STAFF REPORT
COMMUNITY DEVELOPMENT DEPARTMENT

HEARING DATE: 5/4/2021
TO: Mayor & City Council
FROM: Sonya Allen, Associate Planner
208-884-5533
SUBJECT: FP-2021-0027
TM Creek No. 5
LOCATION: Northeast corner of S. Wayfinder Ave.
and W. Cobalt Dr., in the NW ¼ of
Section 14, T.3N., R.1W. (Parcel
#S1214212802)

Final plat consisting of one (1) buildable lots on 8.3-acres of land in the R-40 zoning district for the fifth phase of TM Creek Subdivision.

B. Final Plat (date: 3/29/2021)

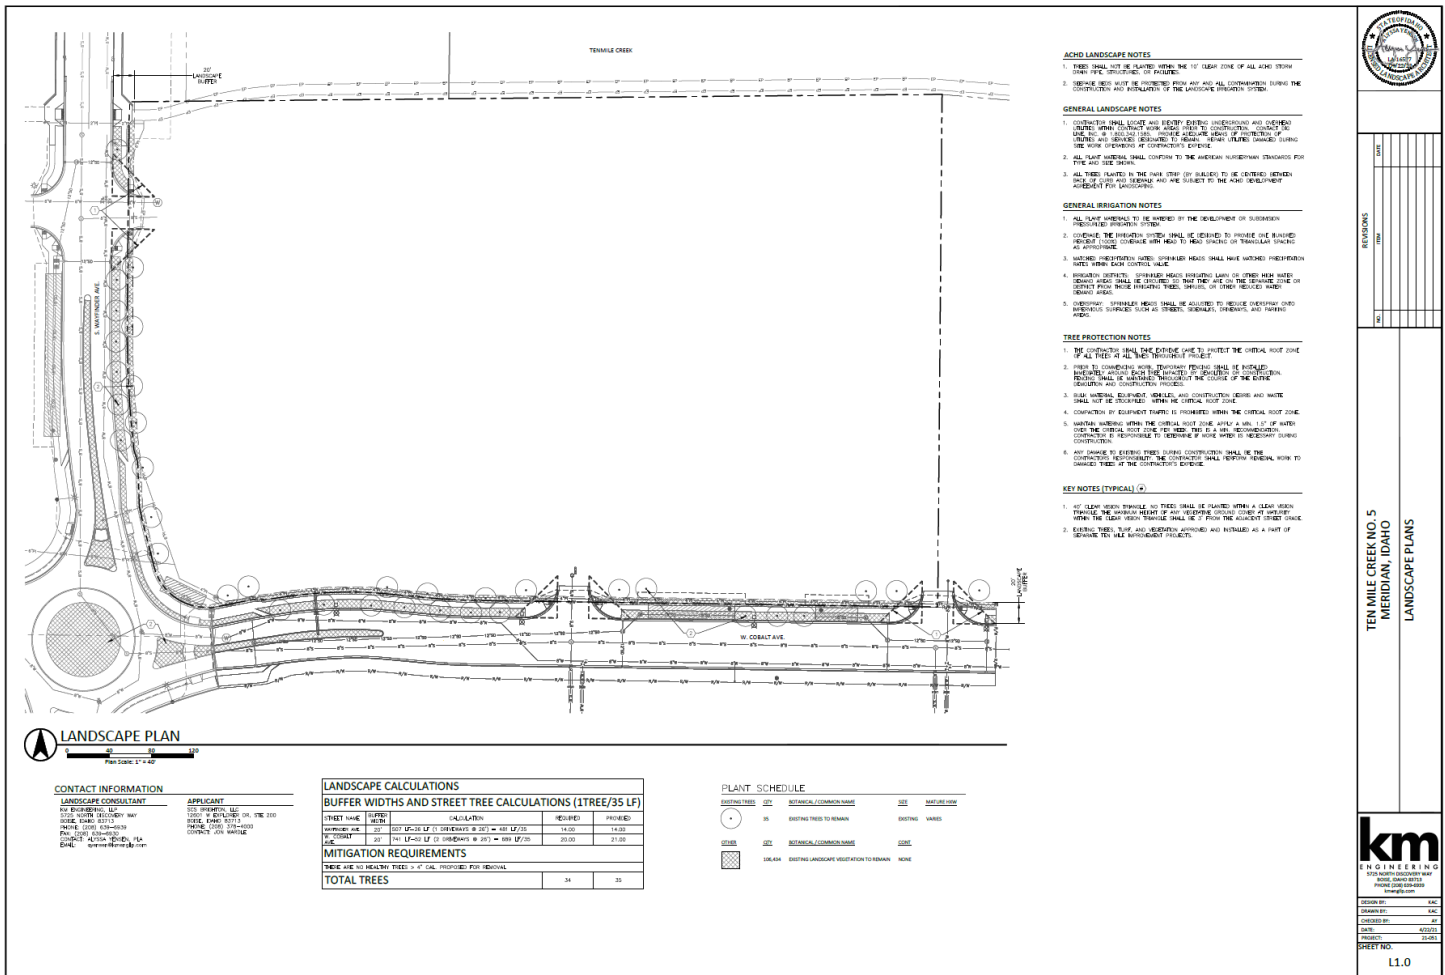
3. Prior to submittal for the City Engineer's signature, have the Certificate of Owners and the accompanying acknowledgement signed and notarized.
4. The final plat shown in Section V.B prepared by KM Engineering, stamped on 3/29/2021 by Aaron L. Ballard, shall be revised as follows:

- a. Graphically depict the location of the ACHD storm water drainage system on Lot 7, Block 3 referenced in Note #9.
 - b. Minimum 20-foot wide street buffers are required along S. Wayfinder Ave. and W. Cobalt Dr., both collector streets, placed in common lots maintained by the homeowner's association as set forth in UDC 11-3B-7C.2a; revise note #13 accordingly. *Street buffers shall be measured from back of curb as set forth in UDC 11-3B-7C.1a(2).*

- c. Include recorded instrument numbers for easements graphically depicts on Sheets 1 and 2.

An electronic copy of the revised plat shall be submitted to the Planning Division prior to signature on the final plat by the City Engineer.
